Access Compliance Report

Public Rights-of-Way

(Pedestrian Signals)

Intersection ID: N/A	Main Street:	Cross Street: N/A	Location: N/A
ADA ID: 92AAE2CFA405	Signal Type: One Push Button-APS	Overall Compliance: No	Severity Score: BTN 1: N/A BTN 2: N/A No BTN: N/A
Codes/Mitigation Info/Possible Solution		Field Measurements/Component Compliance

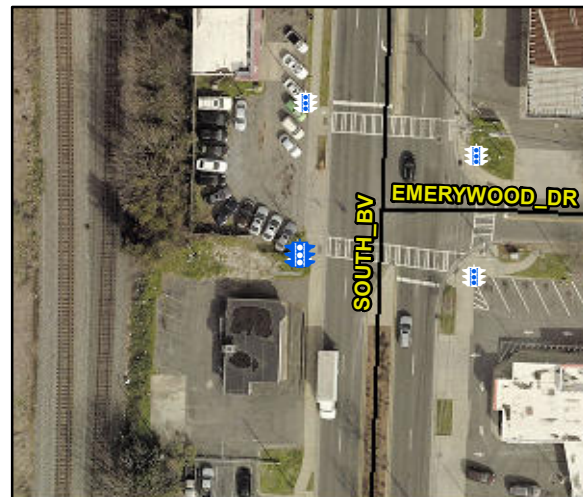
Yes	B 1 Clear Xing Direction?	ClearlyMarked	N/A	B 2 Clear Xing Direction?	N/A
	B 1 Crossing Direction	To E		B 2 Crossing Direction	N/A
Yes	B 1 DistanceTo XWalk (in)	0.0	N/A	B 2 DistanceTo XWalk (in)	N/A
No	B 1 DistanceTo Curb (in)	141.0	N/A	B 2 DistanceTo Curb (in)	N/A
Yes	B 1 Diameter (in)	2.0	N/A	B 2 Diameter (in)	N/A

Possible Solutions: Replace Signal Push Button With APS Button on New Post. Remove & Relocate Sign.
